TOPOGRAPHIC SURVEY
 KAN CUI & LIU YAN
 8636 N MERCER WAY
 MERCER ISLAND, WA 98040

PROJECT NO.	23-154
DRAWN BY:	EFJ
CHECKED BY:	TNW
DATE:	9/11/25
SHEET	1 OF 1

Mercer Island Pergola

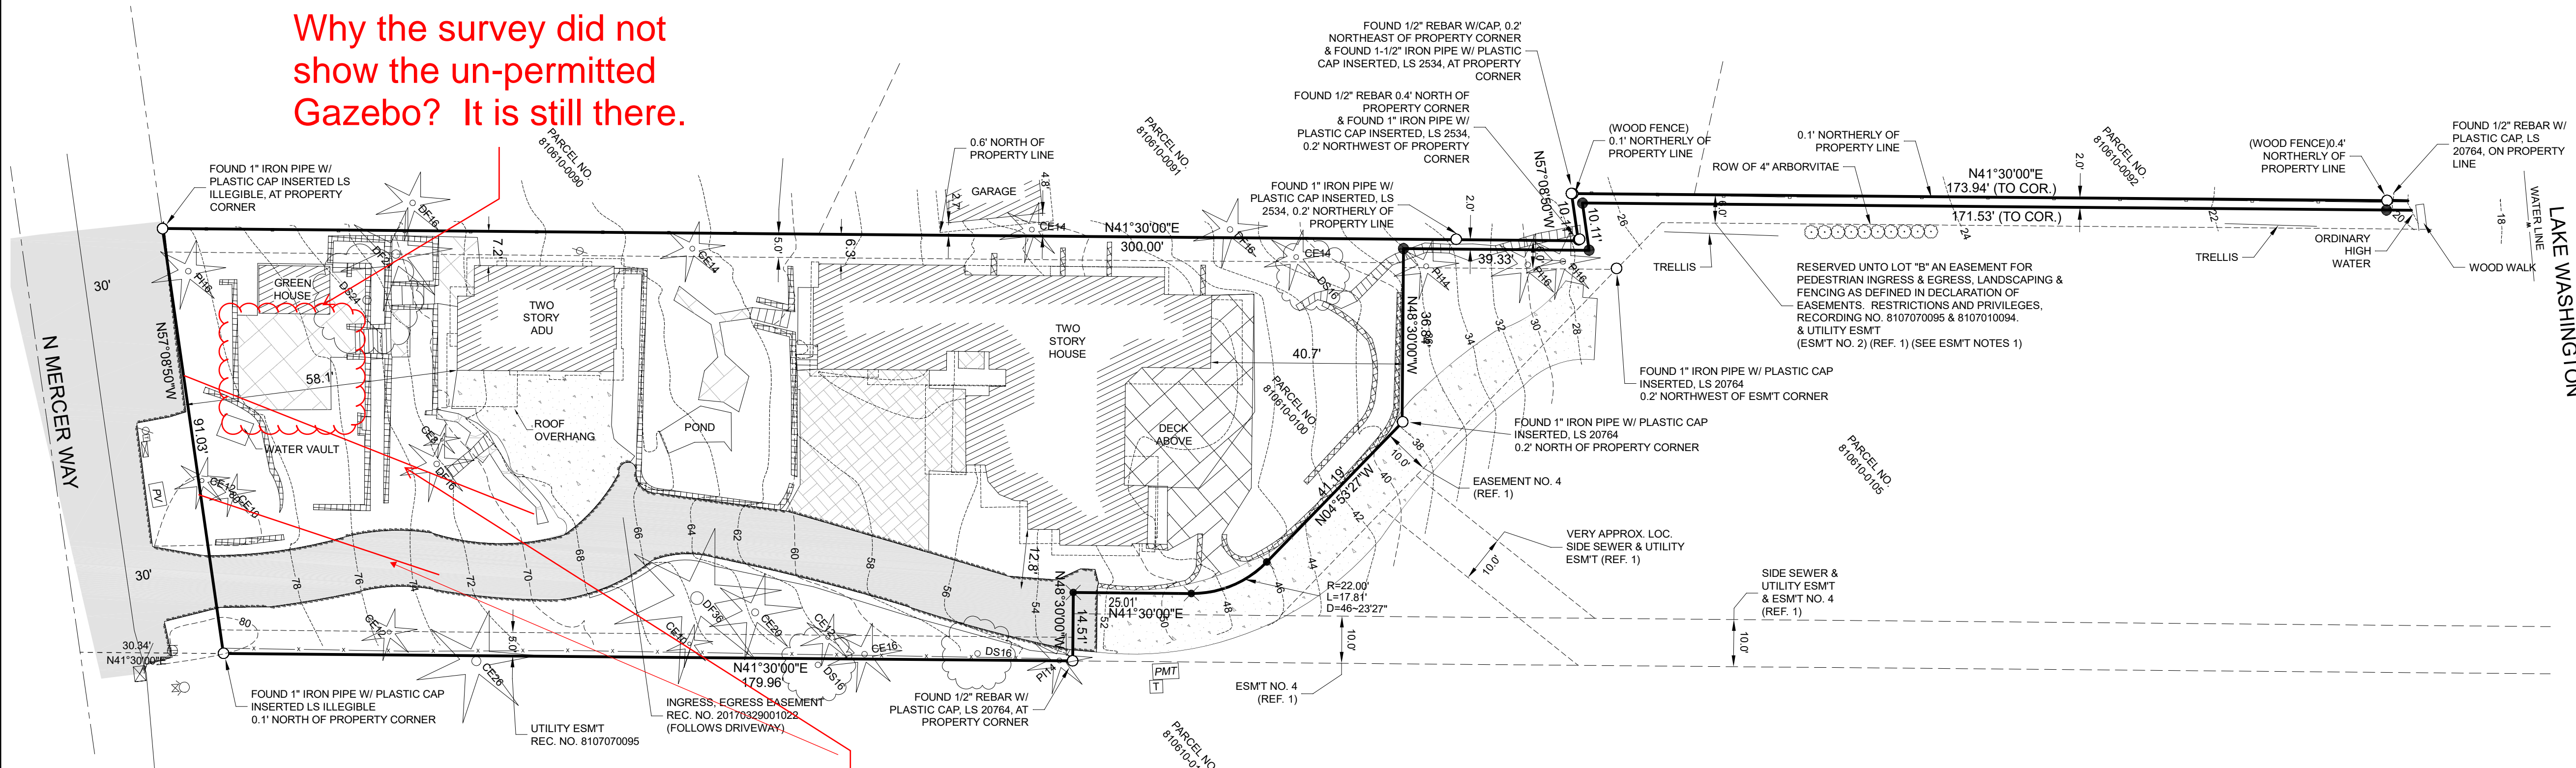
Why the survey did not show the un-permitted Gazebo? It is still there.

The utility easement lines are taken out in this version dated 9-11-2025. Need to add back, shown in 4/4/2023 version of survey.

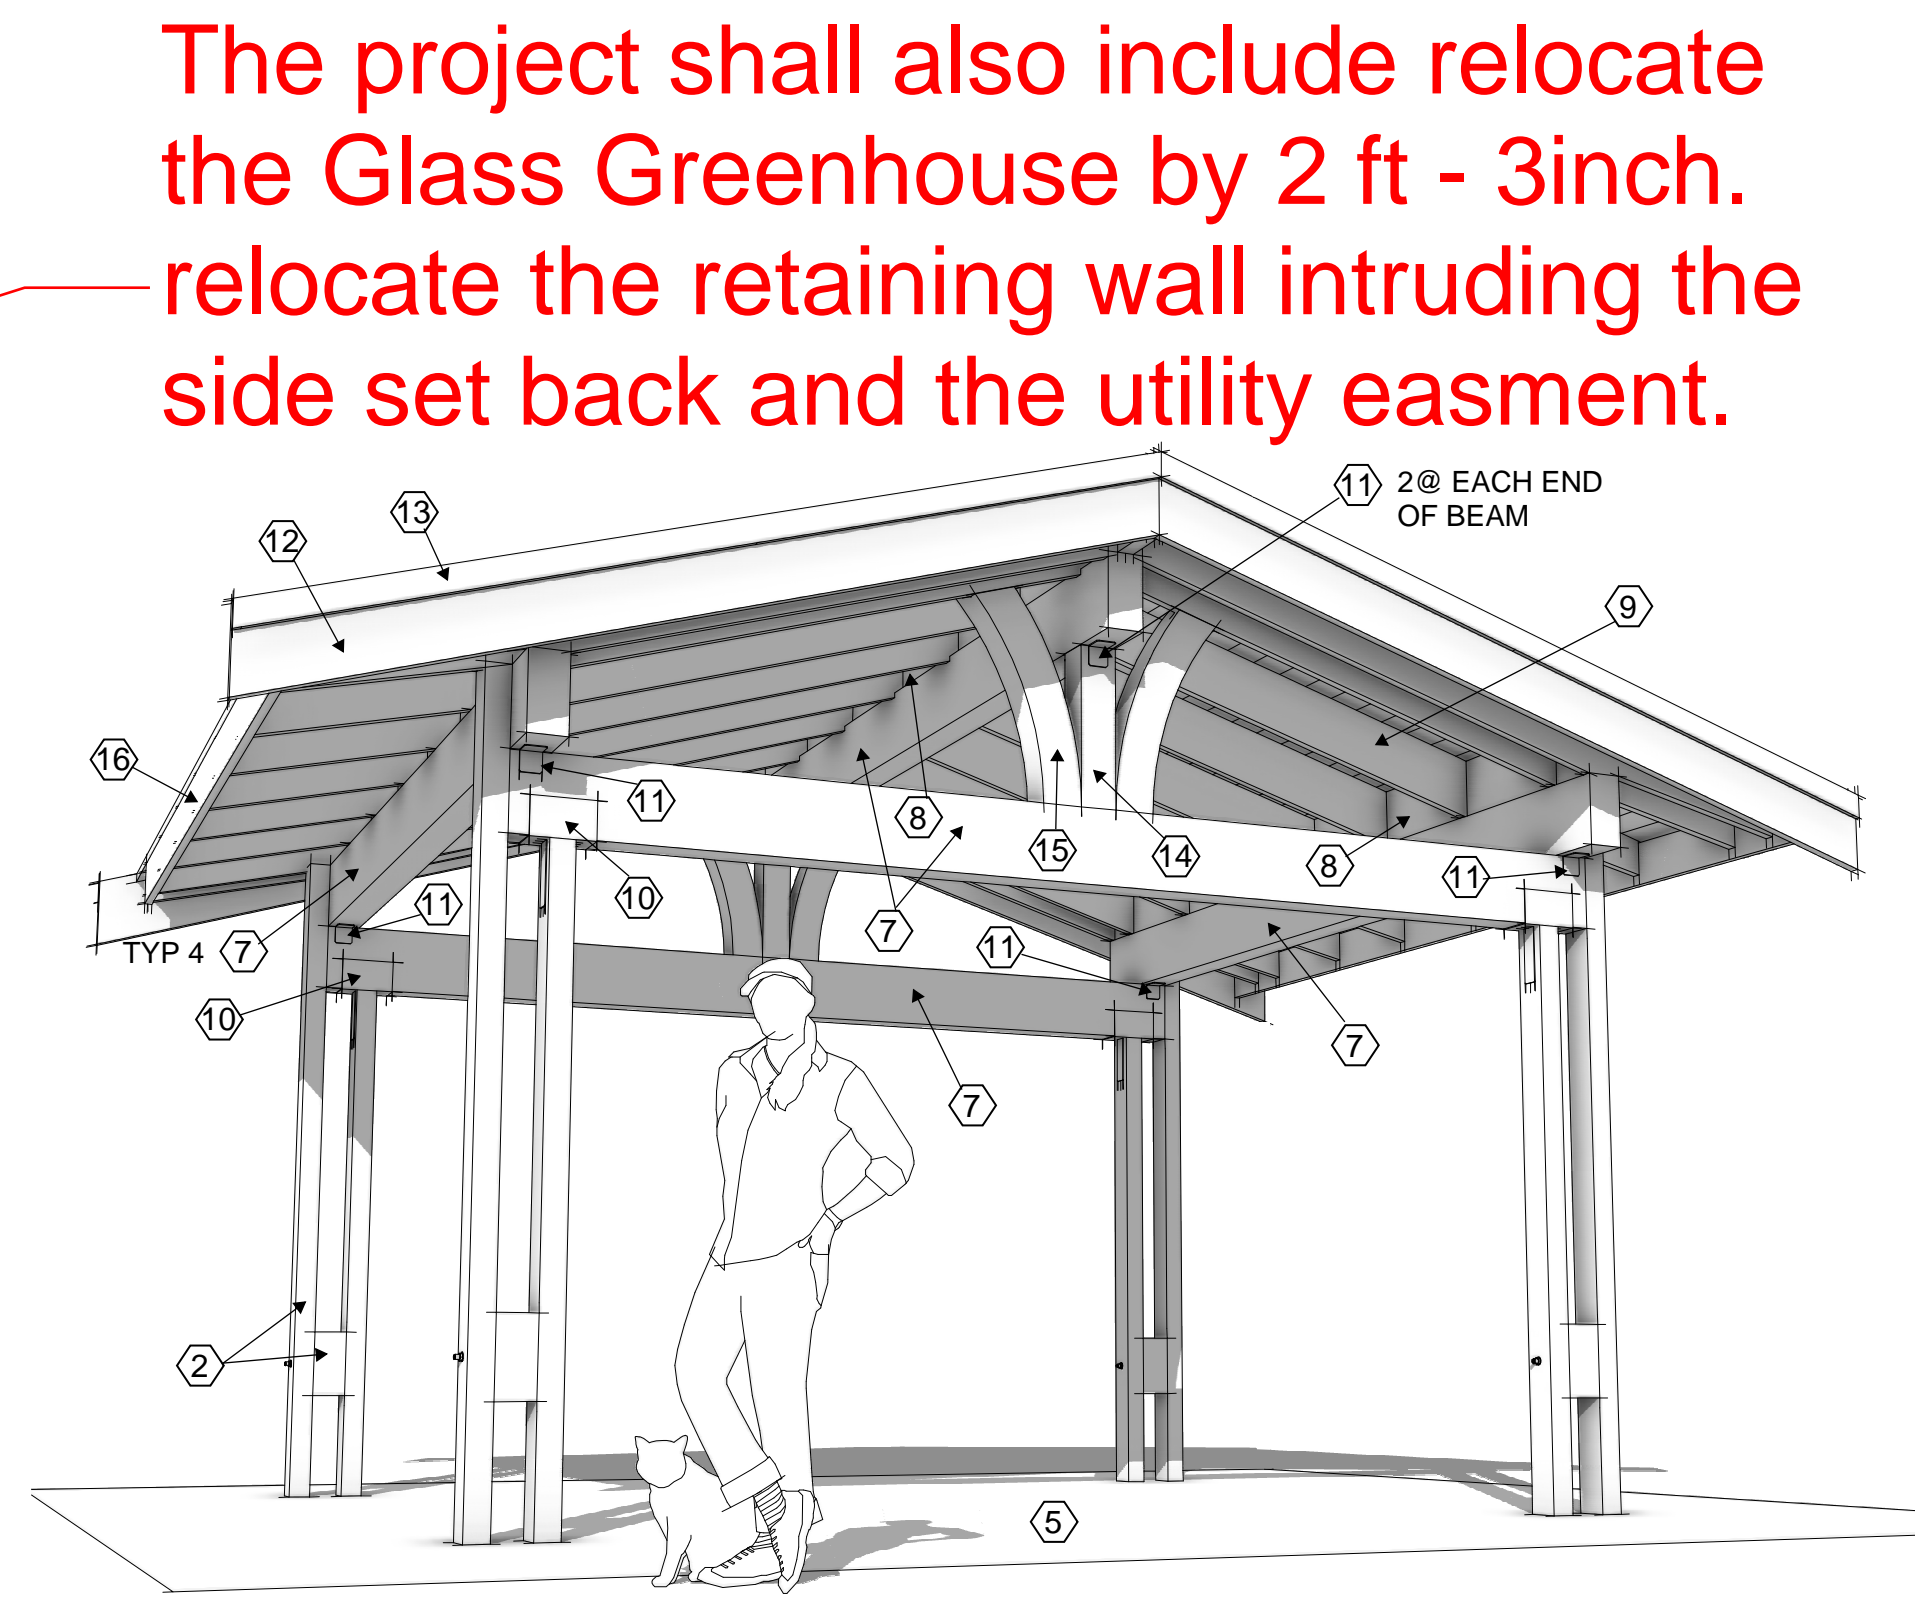
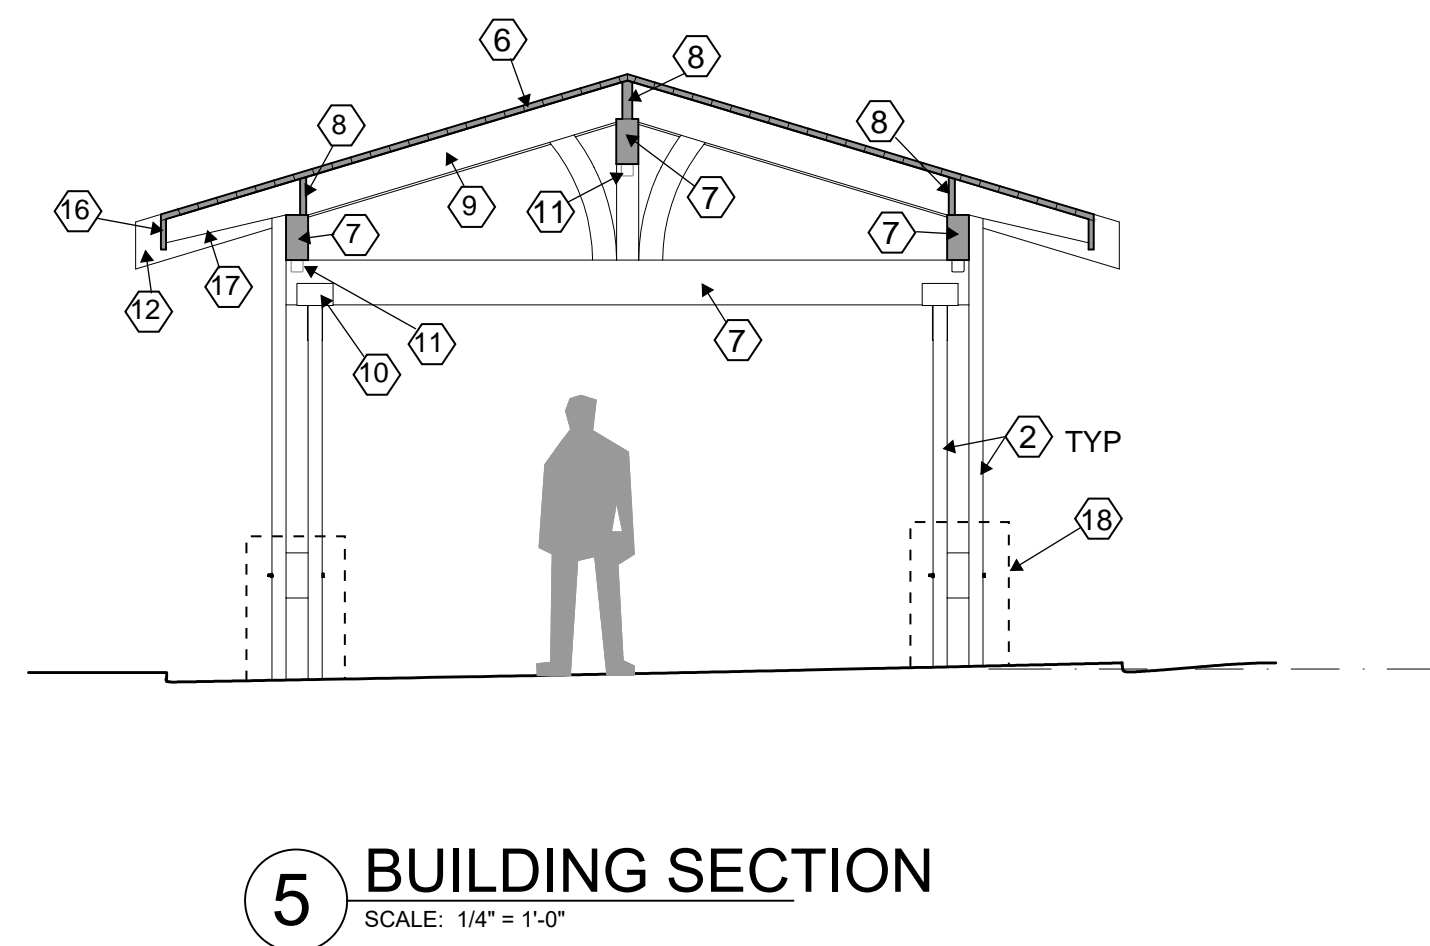
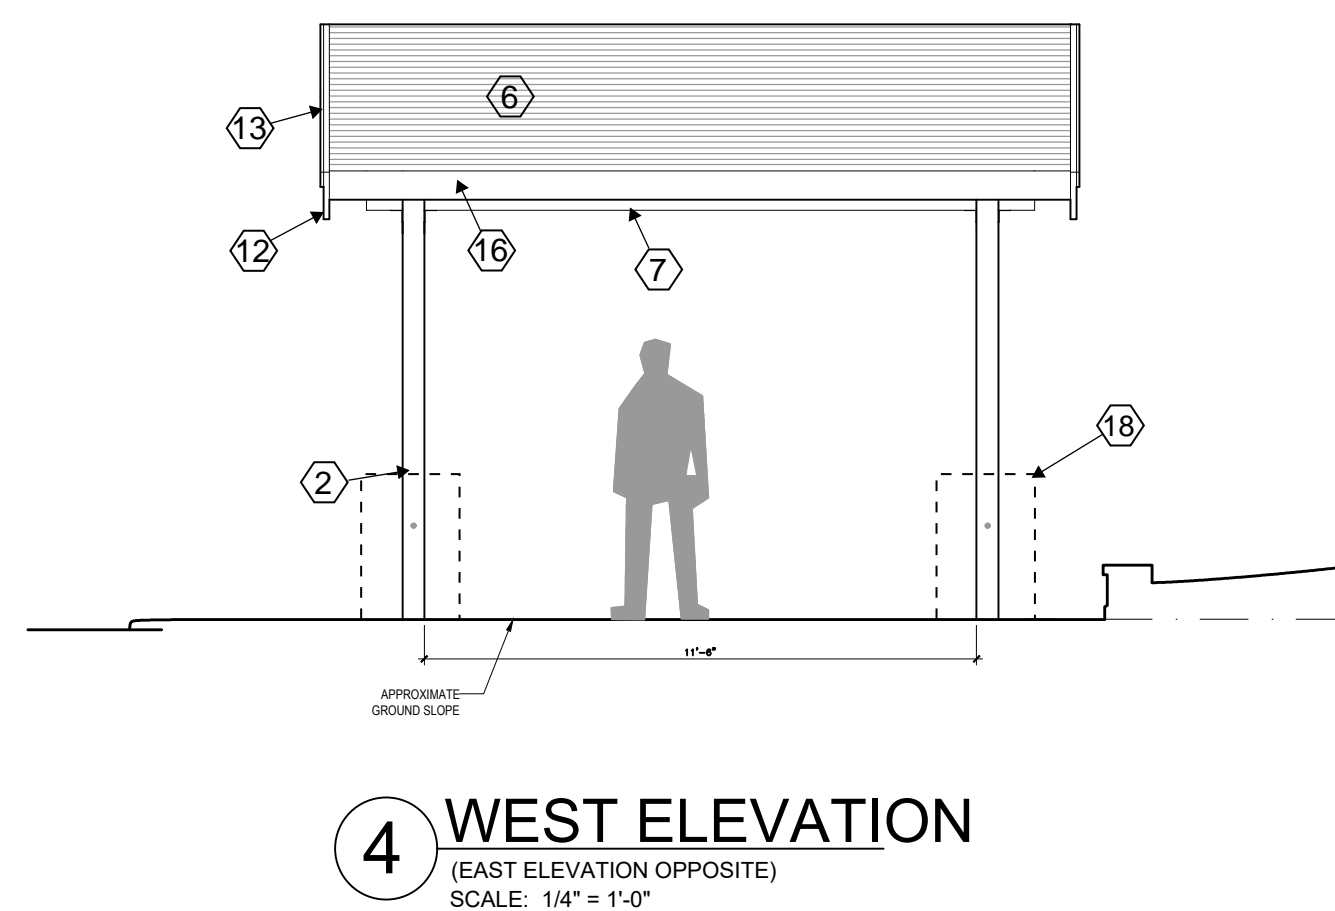
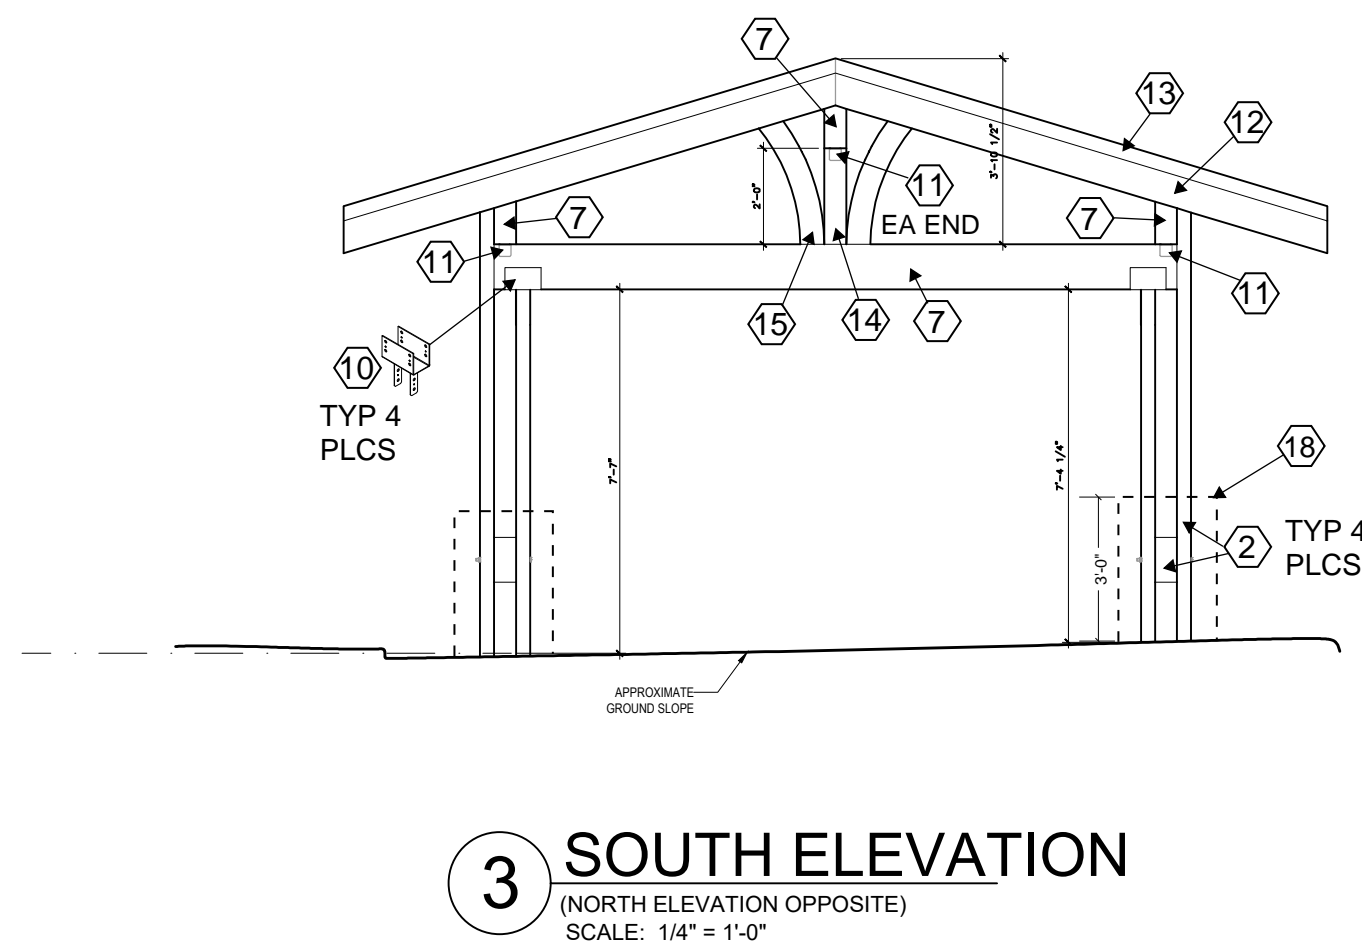
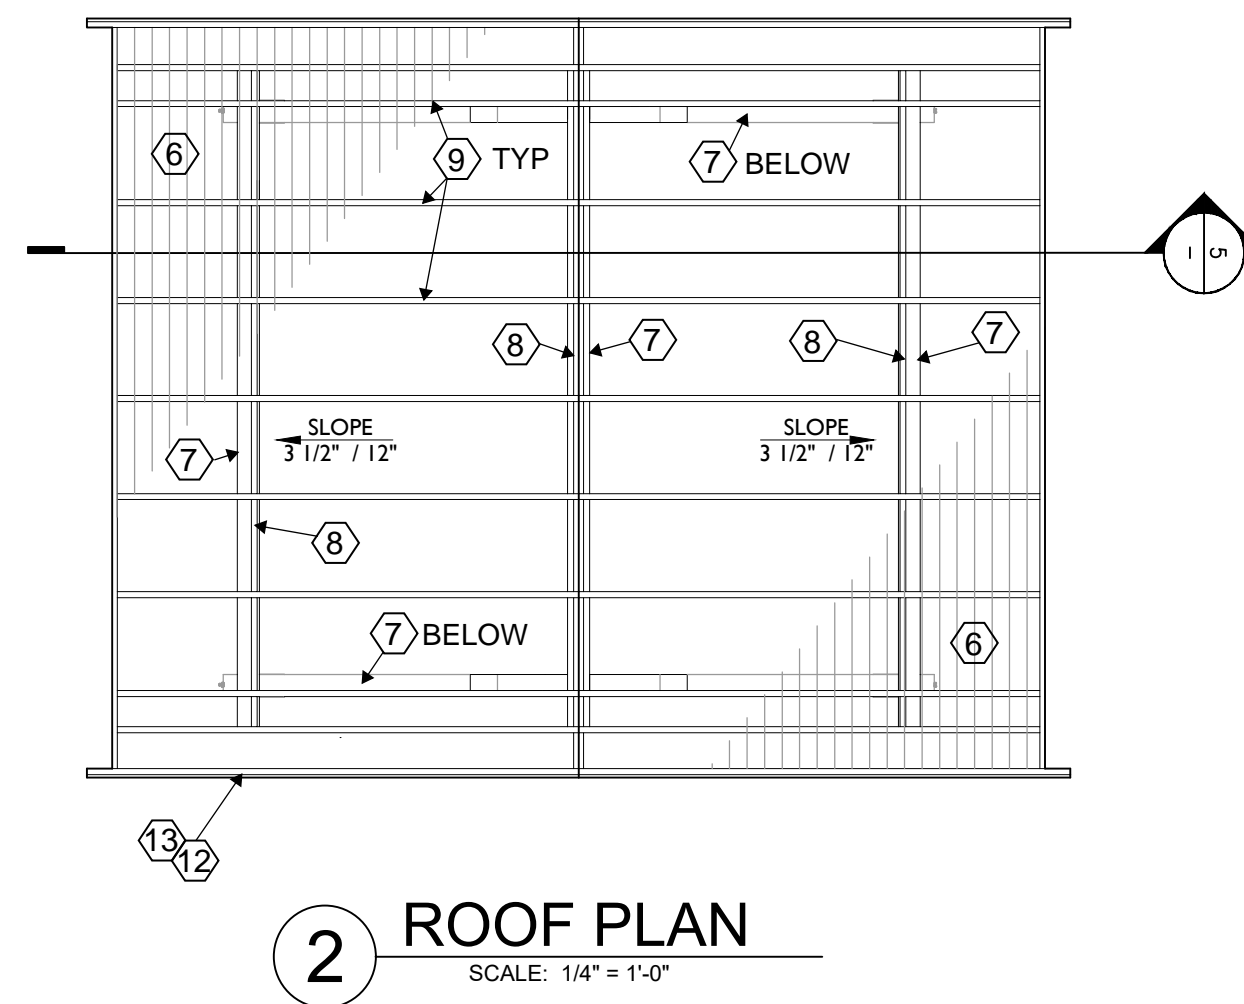
The project shall also include relocate the Glass Greenhouse by 2 ft - 3inch. relocate the retaining wall intruding the side set back and the utility easment.
